TELECOMMUNICATIONS
H 447 Mod Instr No 2

WIRELESS SET C42

TECHNICAL HANDBOOK - MODIFICATION INSTRUCTION

Fig 1 - Position of modification record plate

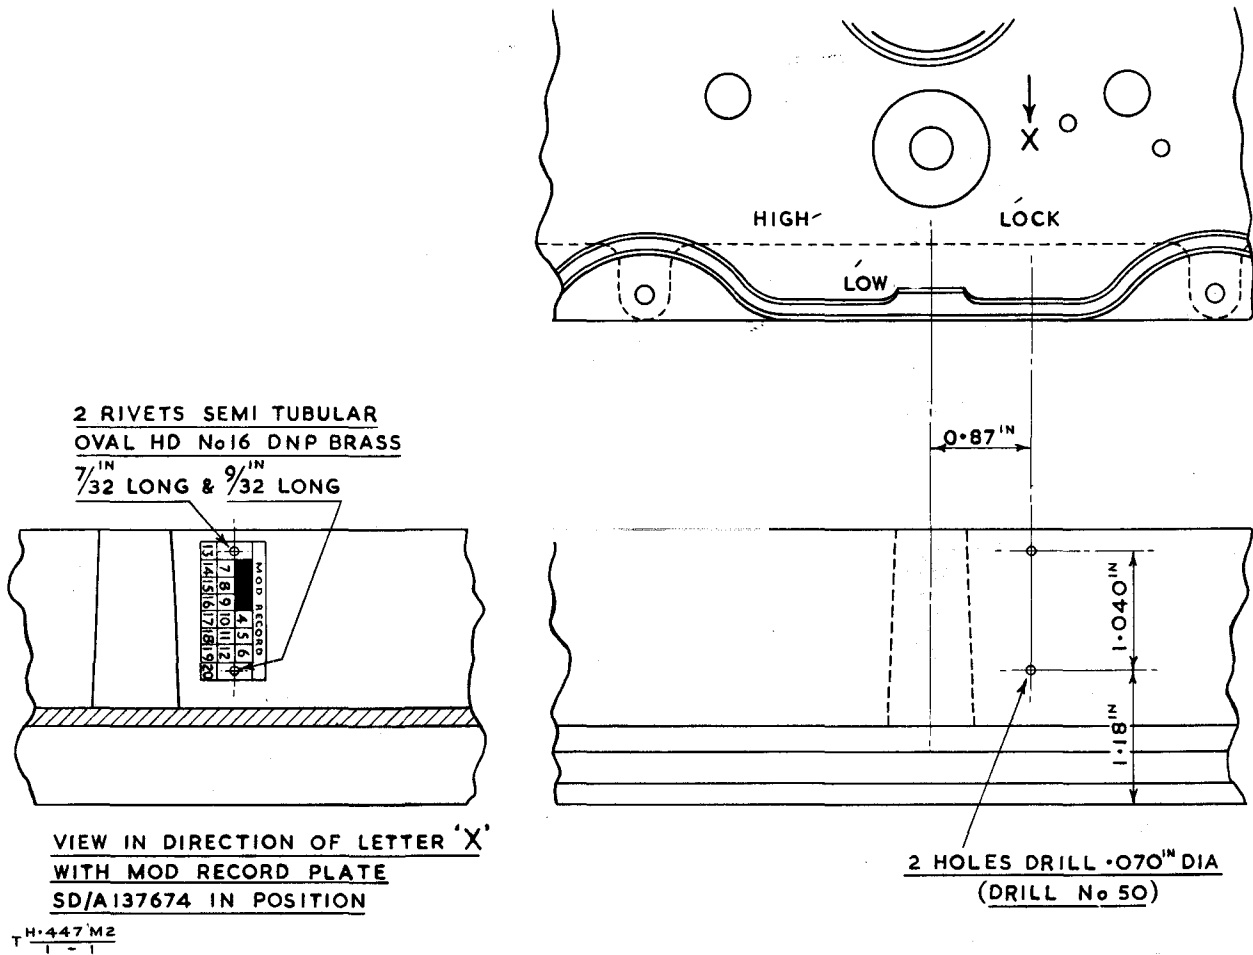
(a) Drill two 0.07 in. diameter holes (No 50 drill) in the bottom ledge of the front of the wireless set to the dimensions shown.

- (b) Fit the modification record plate (YA 9980) as shown, by means of the two rivets provided, using the shorter ($7/32$ in.) rivet nearest the front edge.
- (c) Strike through the numbers 1, 2 and 3 on the plate; these correspond to the following production modifications:-
- (i) No 1 - D.C. heater wiring change (Mod 1 on 1st i.f. unit, a.m.c. unit and main tray)
 - (ii) No 2 - Addition of a low-pass filter to the i.c. amplifier (Mod 1 on the i.c. unit)
 - (iii) No 3 - De-sensitising of squelch circuit (Mod 1 on the squelch unit)

Fig 1 - Modified anode and screen circuit of V24

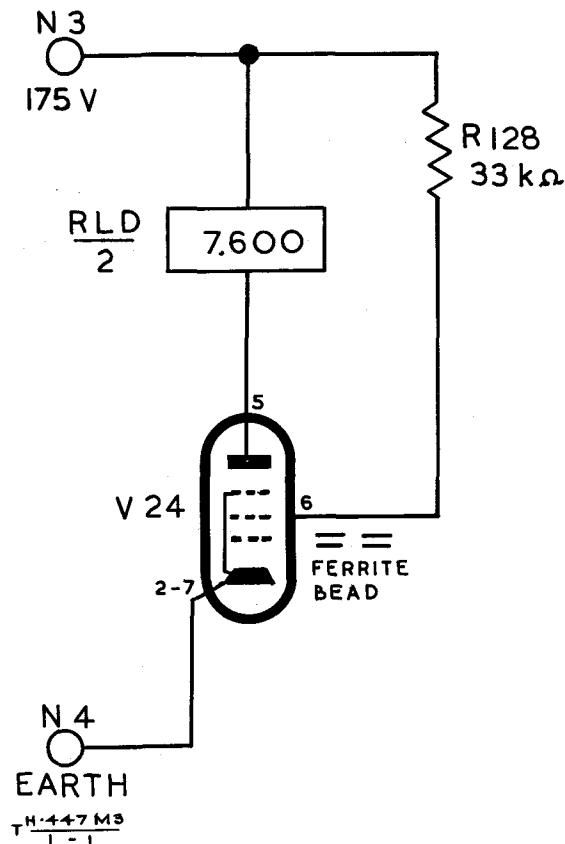
- (c) Remove resistor R129 (10k Ω) from the tag panel on the top of the chassis and replace by a wire strap.
- (d) Remove resistor R128 (68k Ω) from the tag panel on the underside of the chassis and fit the new resistor (33k Ω) in its place.
- (e) Strike through the figure 1 on the squelch unit modification record plate.
- (f) Replace the squelch unit in the set. Replace fixing screws and resolder the pin connections.
- (g) Strike through the figure 3 on the wireless set modification record plate.
- (h) Replace the wireless set in its case. (Refer to Tels H 443, paras 5 - 7 and H 444, Part 1, paras 4 - 14).
- (j) Adjust the setting of the squelch unit preset potentiometer so that the SIGNAL lamp just lights in the absence of a signal with the front panel SQUELCH control rotated clockwise two-thirds of its travel.

Fig 1 - Position of new capacitor C28

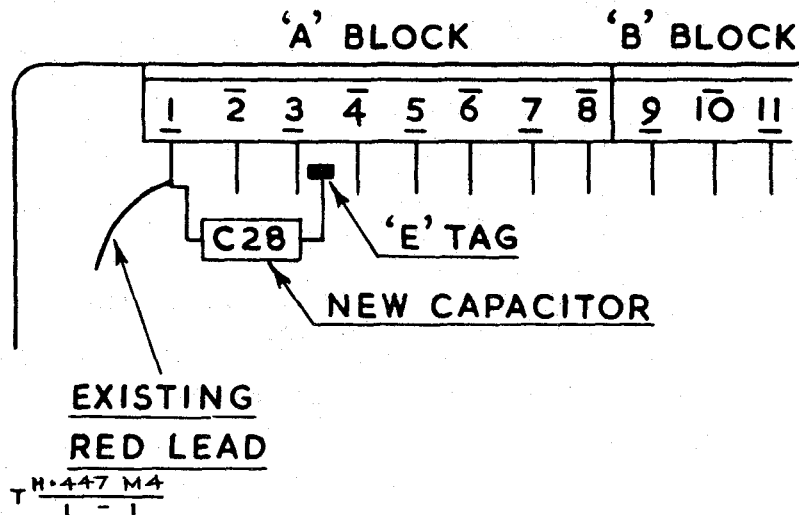
- (e) Remove the unit baseplate from the end section containing the tag blocks A and B.
- (f) Fit the new capacitor (C28) between tag A1 and the adjacent earth tag as shown in Fig 1.

Fig 1 - Underside view of Units, RF, No 8.

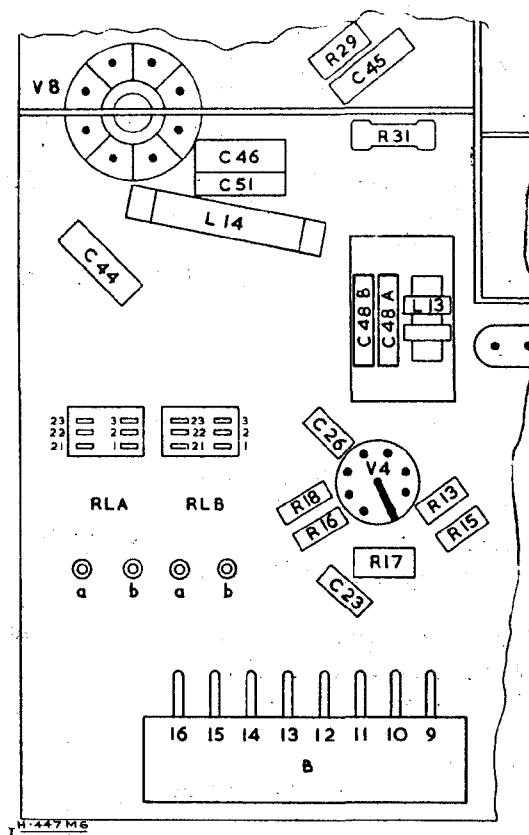
7. (a) Remove the wireless set from its case (refer to Tels H 443, paras 5, 6 and 7 and H 444 Part 1, paras 4-14).
- (b) Open the bottom tray containing Units, RF, No 8, having first tuned the r.f. scale to DATUM (60 mc/s end) and unplugged the c.f.o. lead. Lock the bottom tray in a vertical position.
- (c) Unplug SK7 and unsolder and withdraw all pins connecting 'A' and 'B' block plugs and sockets.
- (d) Remove the r.f. unit from the tray by unscrewing the chrome-plated fixing screws. (Note: To prevent damage to the fingers of the law-corrector fork turn it through 90 degrees).
- (e) Remove the unit base plate from the end section containing the tag blocks 'A' and 'B'.
- (f) Remove the existing capacitor C48 (0.001mF) from the tag panel (Fig 1).

- (g) Fit the two capacitors supplied (C48A and C48B of 470pF each) to the tag panel as shown in Fig 1.
- (h) Replace the base plate on the r.f. unit.
- (j) Strike through the figure 2 on the r.f. unit modification record plate.
- (k) Replace the r.f. unit into the set and reverse the sequence of operation at sub-paras (a) to (c) having first set the law-corrector fork in a vertical position so that it engages correctly with the drive without damage as the tray is closed up.
- (l) Reseal the wireless set into its case (see Tels H 443 paras 5 and 7).
- (m) Strike through the figure 5 on the wireless set modification record plate.

Fig 1 - Circuit and assembly before and after modification

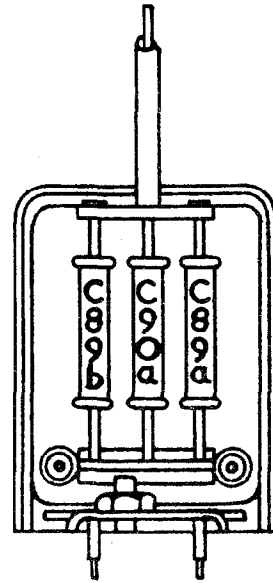
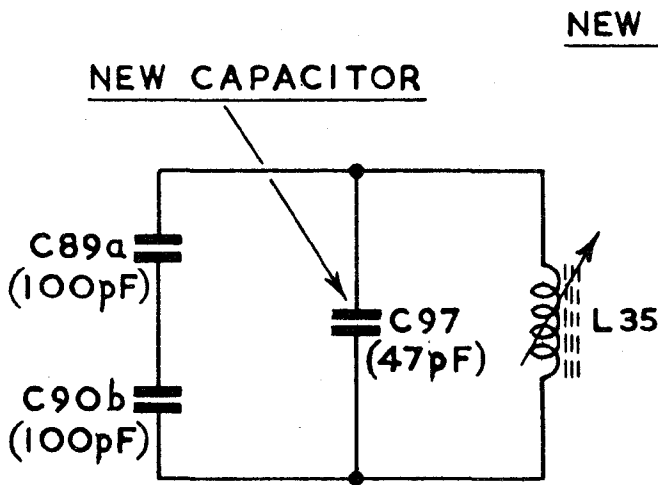
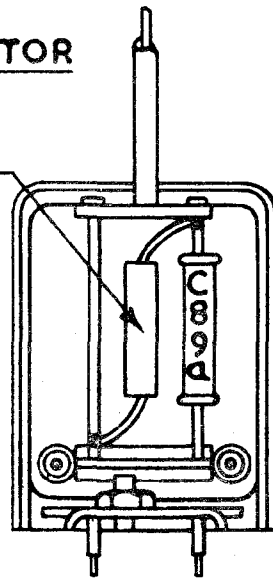
- (e) Locate and carefully remove the two 100pF capacitors C89b and C90a from the discriminator assembly (see Tels H 442, Part 2, Fig 2012).
- (f) Solder and position the 47pF capacitor supplied (Z1 5910-99-940-8513) as shown at Fig 1; ie with one lead of the capacitor connected to the top end of capacitor C89a and the other to the bottom end of the straight-through wire which is revealed by the removal of C89b. The new capacitor is designated C97.

Fig 1 - Component layout

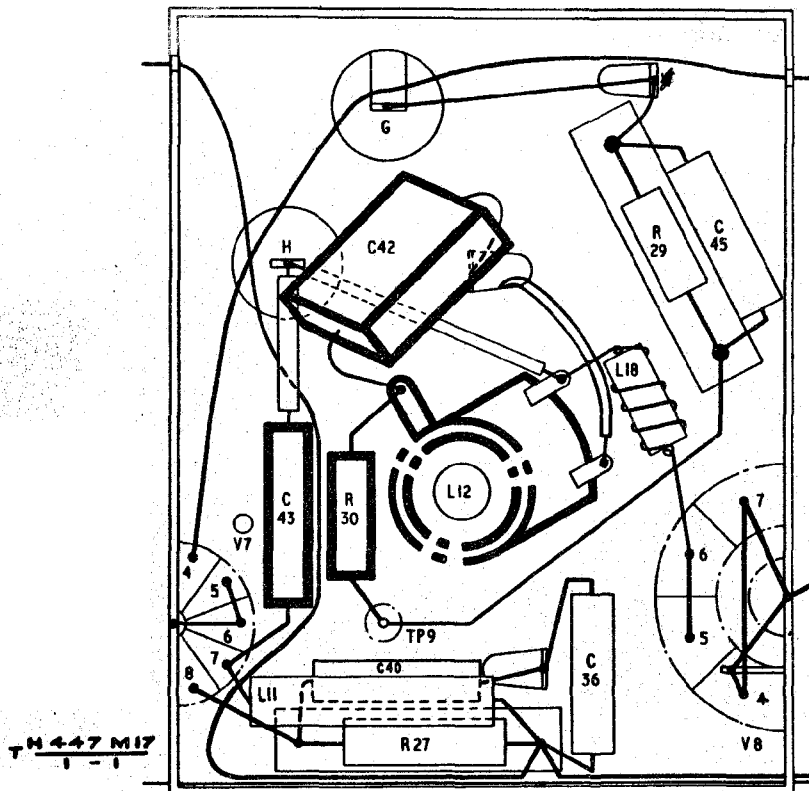
(1) The lead of capacitor C42 from a tag of inductor L12.

(2) The lead connecting inductor L18 and L12 from the L12 tag only.

(3) The sleeved lead, connecting a tag of L12 to capacitor gang section C3E (~~unsolder at both ends, remove and discard this lead~~).

Fig 2 - Modified component layout

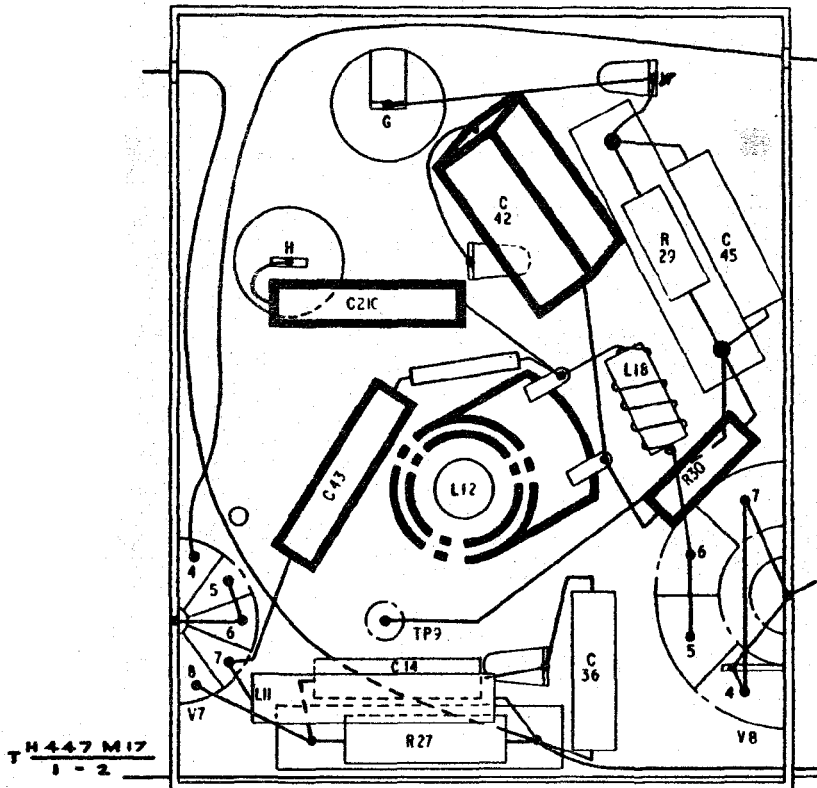
g. Resolder the free leads of inductor L18, capacitor C42, and capacitor C43, to the appropriate tag of the newly fitted inductor L12, positioning and connecting them as shown at Fig 2.

h. Resolder and position resistor R30 (retained in d.(5)) between the appropriate tag of L12 and the junction of resistor R29 and capacitor C45, as shown in Fig 2.

6. Page 4
 - a. Para 7. g., line 1, immediately after 'inductor L18,'
Insert: 'capacitor C3E,'
 - b. Fig 2, Modified component layout
 - (1) Top right-hand corner, adjacent earth tag
Delete: 'W'

Fig 3 - Modified circuit diagram

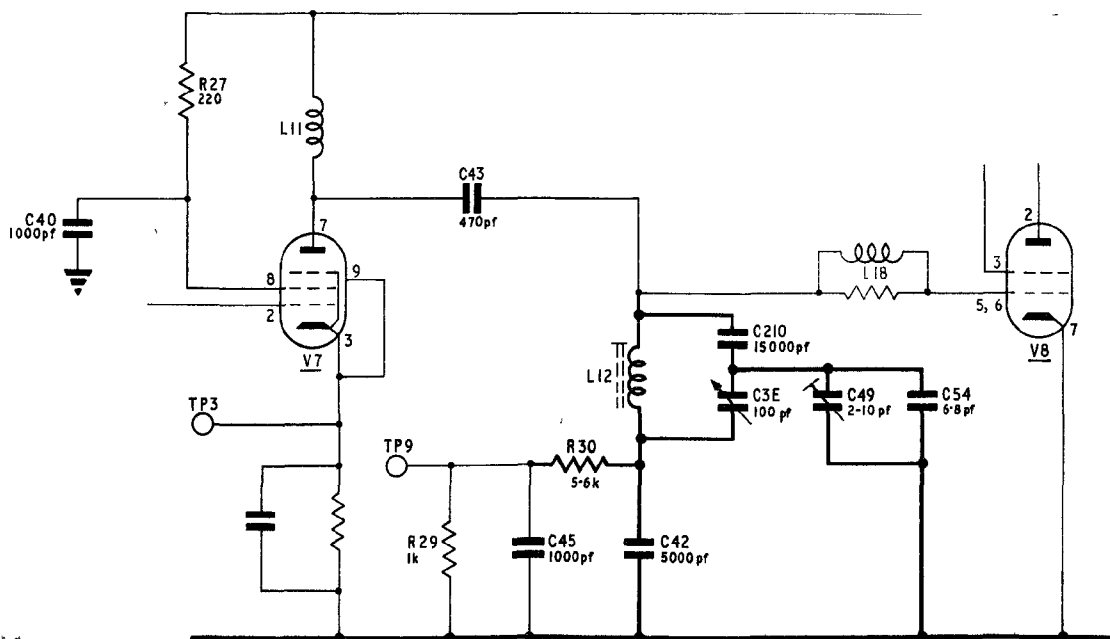
The modified circuit of the TRC42, No 1, driver stage is shown at Fig 3 and Tels H 442, Part 2, Issue 4, Fig 2508 and 2509 must be amended as follows:-

Insert symbol representing new capacitor C210
in a vertical position above C42. | |

Fig 1 - Scrap layout diagram, showing modified V18 and V19 locations

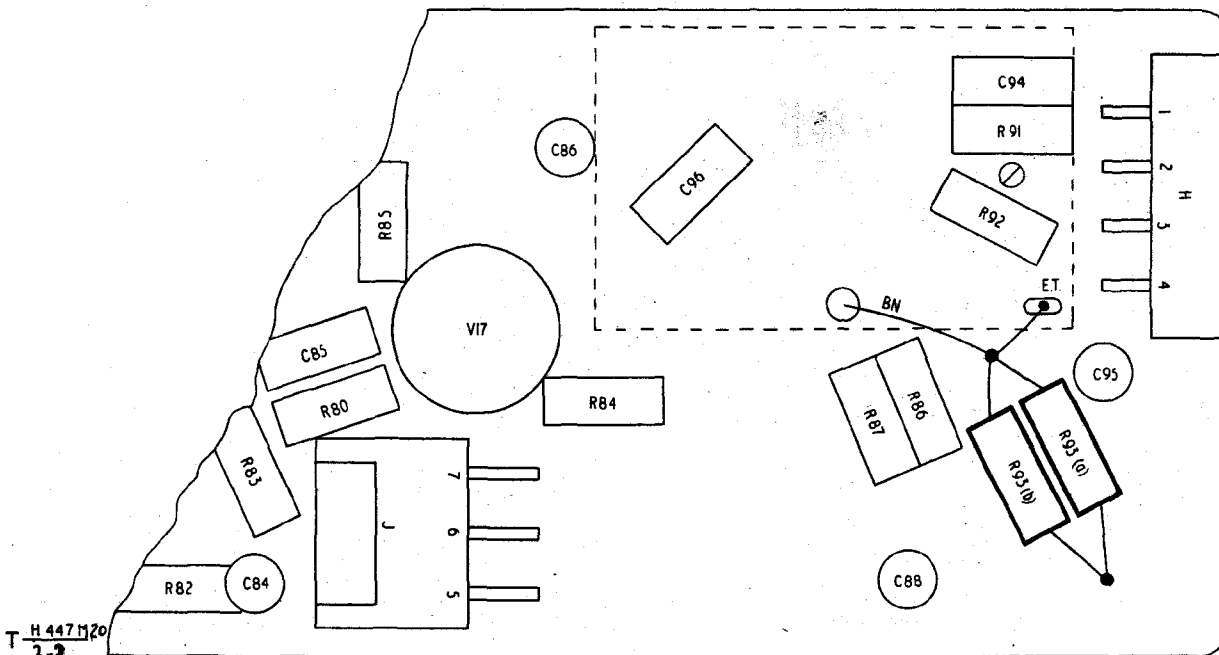
h. Fit the two semiconductor diodes (supplied) into the lower clips of V18 and V19 (Fig 1). Cut the cathode lead of V18 diode and the anode lead of V19 diode to $5/8$ in. each. Some diodes are incorrectly marked. Before the leads are cut, check the polarity with a multimeter. Normally the cathode is identified by a white spot on the diode body. If the marking is incorrect, carefully scrape off the white paint before cutting the leads. Fit each of the cut leads with a $3/8$ in. length of pink sleeving and solder each to the terminal nearest to its particular clip (these are the terminations of the $82k\Omega$ resistors R88(V18) and R89 (V19) respectively). A heat shunt (see Tels A 522, para 5-6 and Fig 1) must be used on the diode leads while soldering, using the minimum of heat consistent with good joints.

j. Cut the anode lead of the V18 diode and the cathode lead of the V19 diode to a length of $1.3/8$ in. each. Fit each of these leads with a $1.1/8$ in. length of pink sleeving, and solder them to the terminals at the remote ends of R88 and R89 respectively, observing the same soldering precautions as indicated in sub-para h. (see Fig 1).

Fig 3 - Scrap circuit diagram, after modification

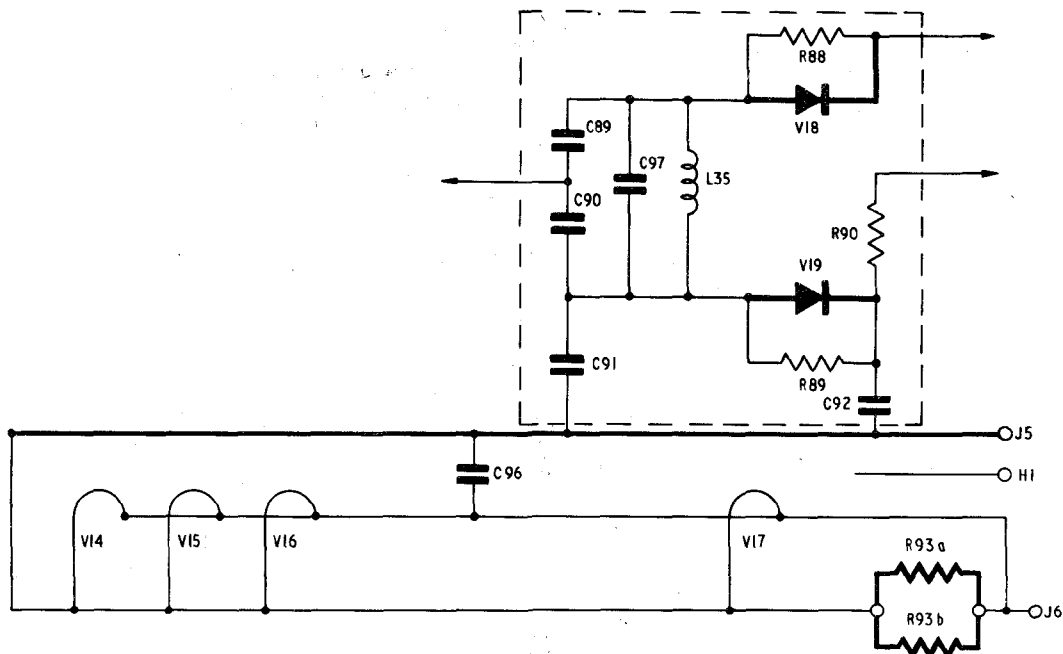
The circuit alterations effected by carrying out the action detailed in para 7 are represented in Fig 3. The following amendments to Tels H 442, Part 1, and Tels H 442 Part 2, will therefore be published in due course:-

- a. Tels H 442, Part 1, Issue 1, para 47, second line, the words 'two CV469 type diodes' to be amended to 'two semiconductor diodes CV9374'.
- b. Tels H 442, Part 2:
 - (1) Fig 2502, Page 1004, Issue 2, grid ref DE6-7, R93a and b to be shown as 47Ω, and the symbols representing the heaters of valves V18 and V19 to be deleted, and replaced by a line indicating a short-circuit.
 - (2) Fig 2505, Page 1007, Issue 3, grid ref W3-4, the valve symbols for the diodes V18 and V19 to be replaced by semiconductor diode symbols.
 - (3) Fig 2513, Issue 2, Page 1020
 - (a) Grid ref G2-3: the valve symbols shown for the diodes V18 and V19 to be replaced by semiconductor diode symbols.

Fig 1 - Scrap layout diagram, showing modified V18 and V19 locations

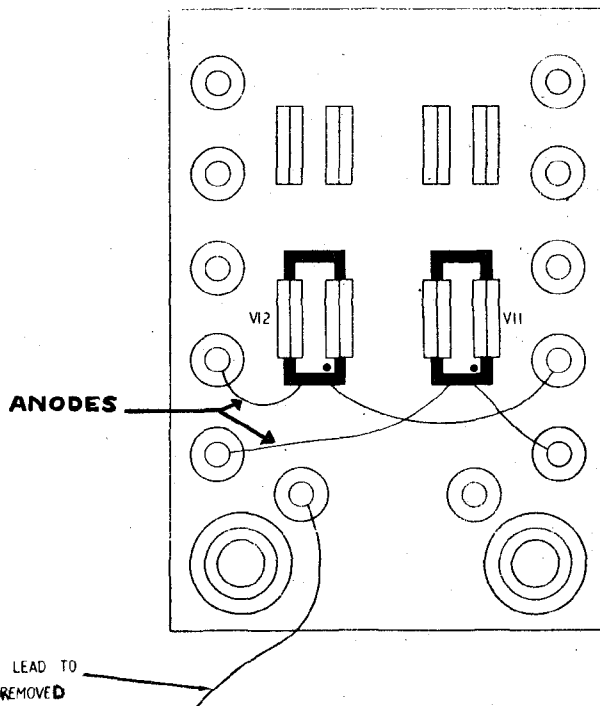
- h. Fit the two semi-conductor devices supplied, one into the inner clip of V11 and the other into the inner clip of V12, as shown in Fig 1.

l. Unsolder and discard the brown lead which is connected to a terminal of the discriminator unit adjacent to the bottom end of the inner clip of V12 (see Fig 1)

Fig 2 - Scrap layout diagram, showing location of R68 and wiring modification

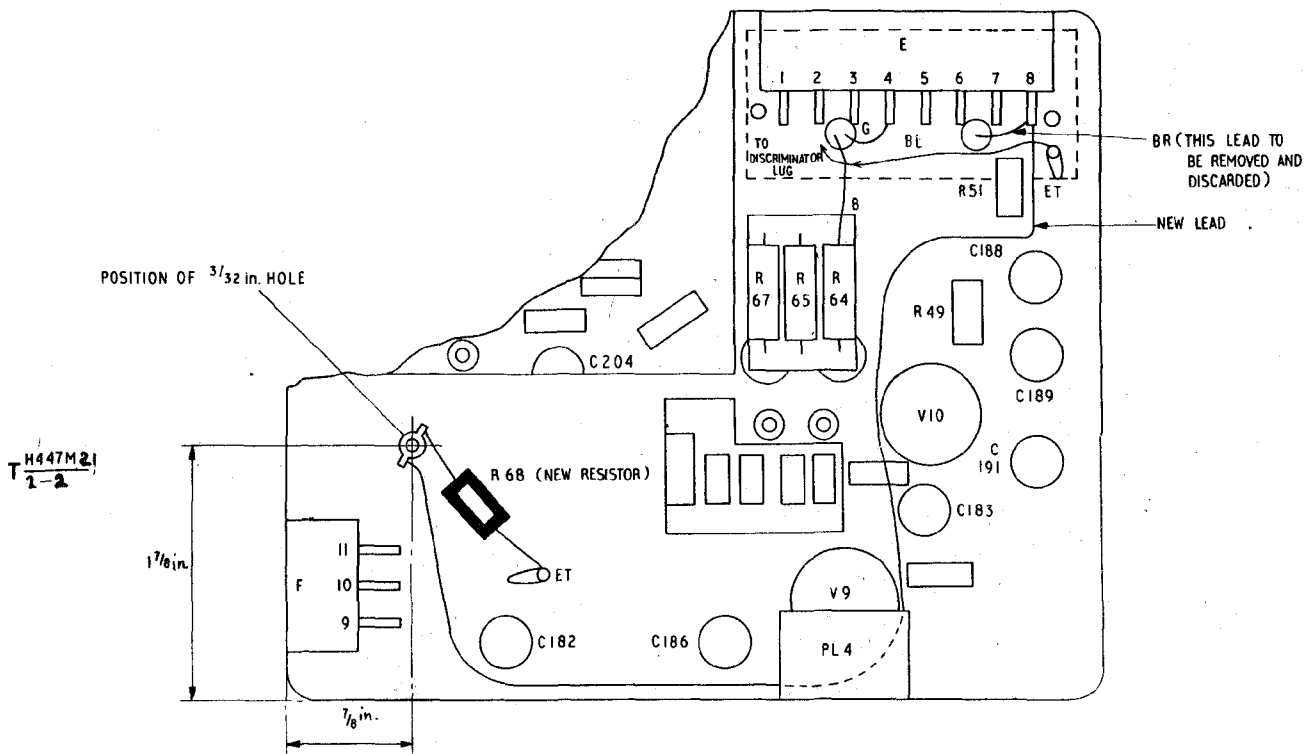
m. Mark out the position (as shown in Fig 2) and drill a hole using a $\frac{3}{32}$ in. or No 42 drill. After removing any burrs etc, apply a thin coat of electrical insulating varnish (8010-99-943-3454) to the cut edges of the hole.

Fig 2 - Scrap circuit diagram, after modification

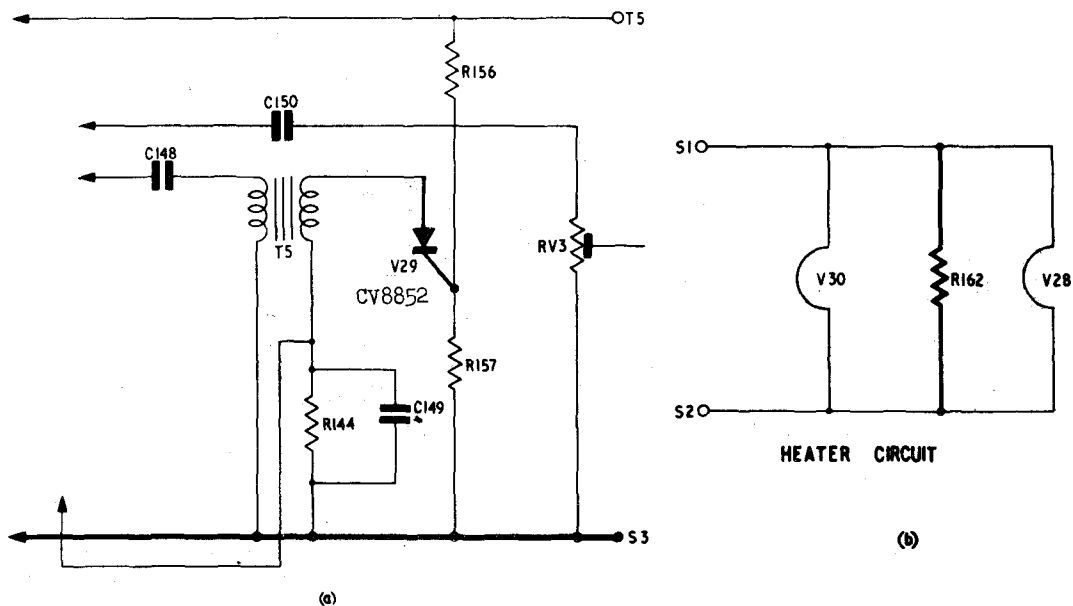
The circuit alterations made by carrying out the action detailed in para 7, are as shown in Fig 2. The following amendments to Tels H 442, Part 2 will therefore be published in due course:-

- a. Fig 2502, Page 1004, Issue 2, grid ref C7: the symbol representing the heater of valve V29 to be deleted and resistor R162 to be amended in value to 47Ω , and shown in parallel with the heaters of V28 and V30.
